<b>McCORMICK</b>	<b>Service Bulletin</b> <b>Product Upgrade Programme</b>		<b>DBT6008/2GB</b>
	Replaces: DBT6008/1 which should be destroyed.		
	DBT Model Range: <b>C, CX, MC &amp; MTX Series</b>		
Date:           August 2003	Paper Colour - Blue	Binder:	<b>Agricultural Tractors</b>
Reference:	Issued by:       Product Support, Doncaster

**Models Affected:**     MC80, MC90, MC100 and MC115  
MC120 and MC135 Power6  
MTX110, MTX125 and MTX140  
MTX155 and MTX175

**Subject:**               **Speed Sequencer Upgrade – Range Modulation**

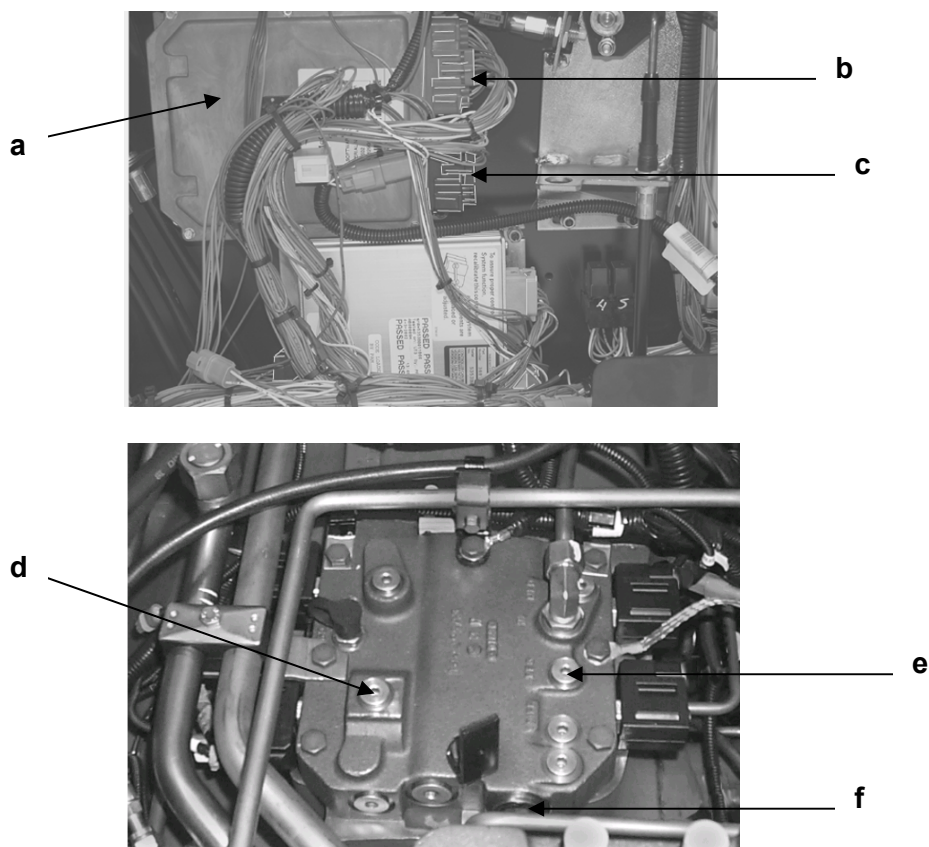
Before carrying out any work ensure the tractor is parked on firm ground with the handbrake applied and shuttle in neutral. Select mechanical neutral in the gearbox by starting the engine and pressing the shift up and shift down buttons simultaneously and holding until the speed display reads **0**.

- 1) Remove R/H console side panel.
- 2) Remove speed sequencer control module (a)
- 3) Fit new speed sequencer control module - at this point **do not** connect the red and black plugs to the new control module (b and c)
- 4) Remove rear cab skirt (if fitted), to gain access to shuttle valve.
- 5) Remove plug (d) and replace with elbow 700-304
- 6) Remove plug (e) and replace with 'T' piece 700-401 ( Use Cap 700-900 if required )

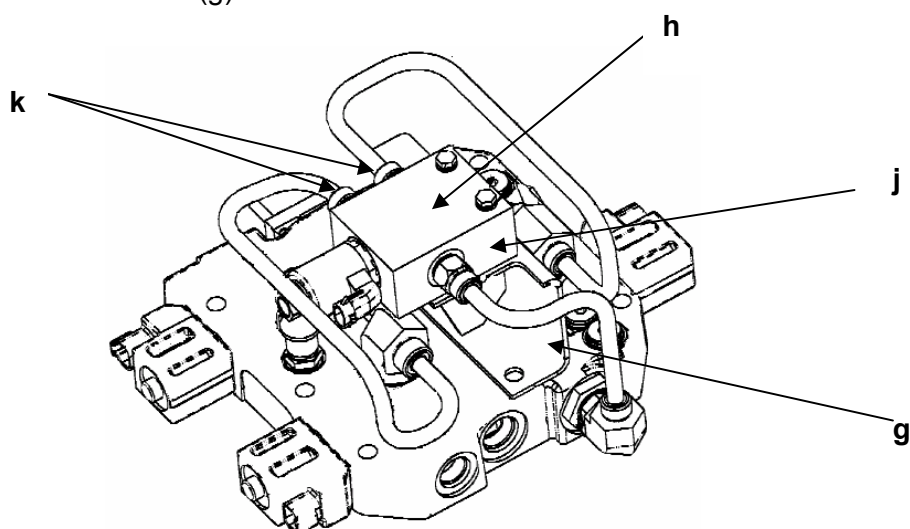
- 7) Remove plug (f) and replace with plug 704440A1
- 8) Assemble into plug 704440A1
  - Elbow 700-304 (MC and MTX110 to 140)
  - Elbow 700-315 (MTX155 to 200)
- 9) Fit bracket 704450A1 (g) to shuttle valve.

- 10) Mount modulation valve 704451A1 (h) to bracket (g) and secure.
- 11) Fit check valve 223971A1 (j) to modulation valve.

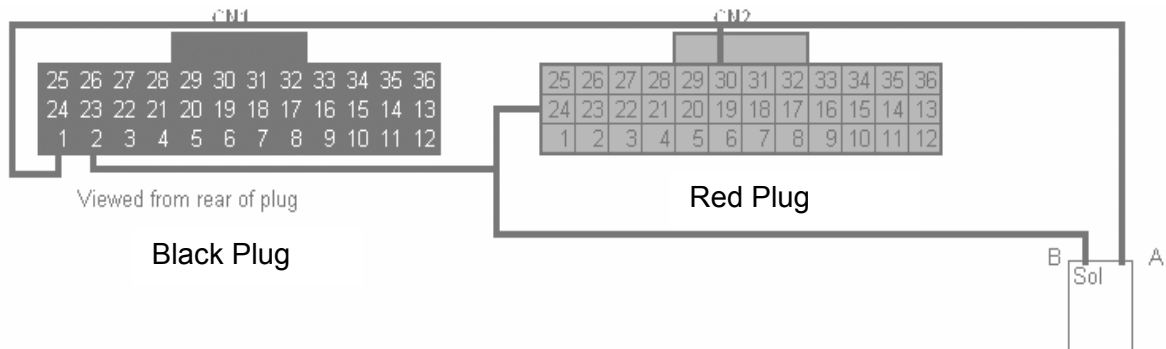
- 12) Fit connectors 700-101 (k) to modulation valve.
- 13) Connect pipework between shuttle valve and the new modulation valve.
- 14) Connect new harness to the modulation valve solenoid.
- 15) Route new harness along transmission and through cab floor into front of R/H console.
- 16) Connect red wires to speed sequencer module connectors black cavity 1 and red cavity 30.
- 17) Connect tan wires to speed sequencer module connectors black cavity 2 and red cavity 24.
